# SERVICE BULLETIN

REPUBLIC AVIATION CORPORATION  
FARMINGDALE, LONG ISLAND, NEW YORK  
SERVICE DEPARTMENT

SERVICE BULLETIN NO. 5

## INSTALLATION NEW TYPE ELEVATOR PULLEY GUARD

Figure 1

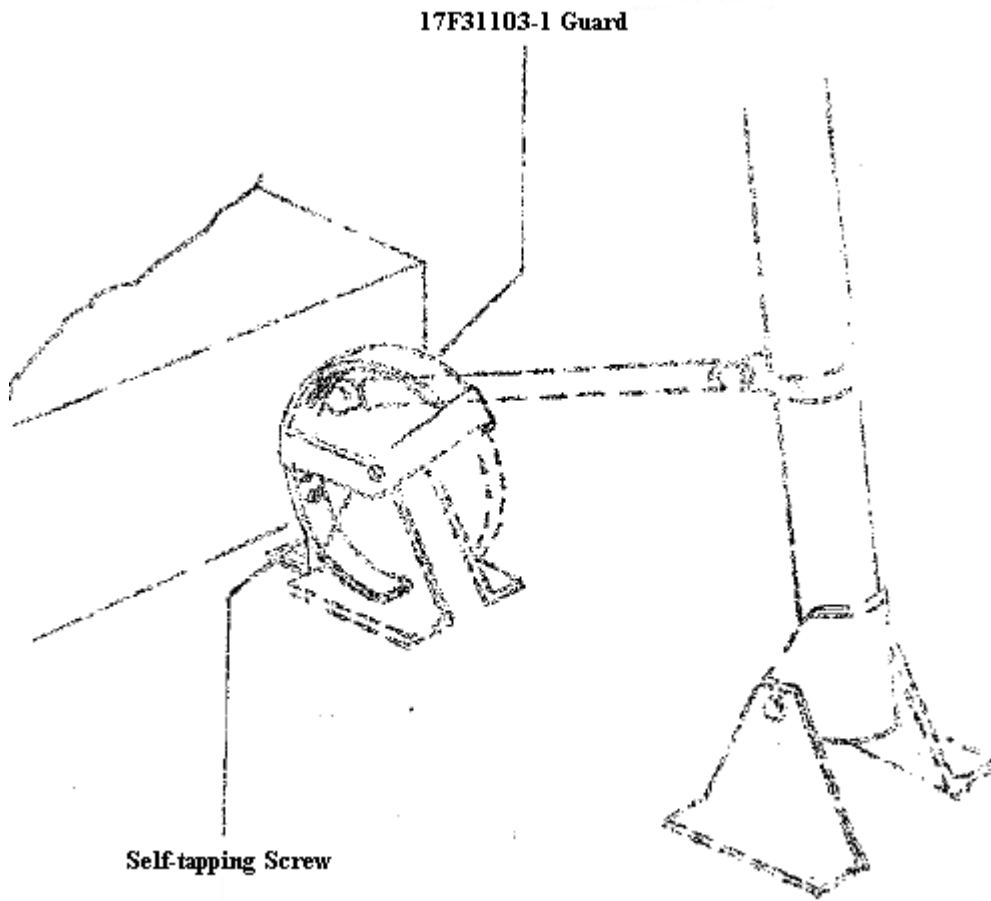
Reason for Change: To provide a more definite means of preventing elevator control cable from coming off pulley.

This change involves removing the present elevator pulley guard from the pulley Forward of the control column and installing new guard in its place and shall be accomplished as follows:

3. Loosen bolt and nut holding elevator control pulley forward of control column to its support. This will permit the removal of the present guard.
4. If the head of the bolt holding the pulley is on the right hand side of the pulley support, remove the nut from the bolt and slip the new guard in place on the left side of the pulley. However, if the head of the bolt holding the pulley is on the left side, this bolt must be removed using another 1/4" diameter bolt to push the bolt out and to hold pulley in place because of existing tension in elevator control cable. Place Guard 17F31103-1 in position on outside of left hand pulley support and fasten it in place using original hardware. Refer to figure 1.

1. Remove brake pedals from top of rudder pedals to obtain free access to elevator control pulley forward of control column.
2. Remove lead ballast forward of pulley.

5. Attach forward tab of guard to deck using self-tapping screw. Drill a #34 (.111) hole in the deck using hole in tab of guard as a guide.
6. Replace ballast and pedals and make suitable entry in log book.
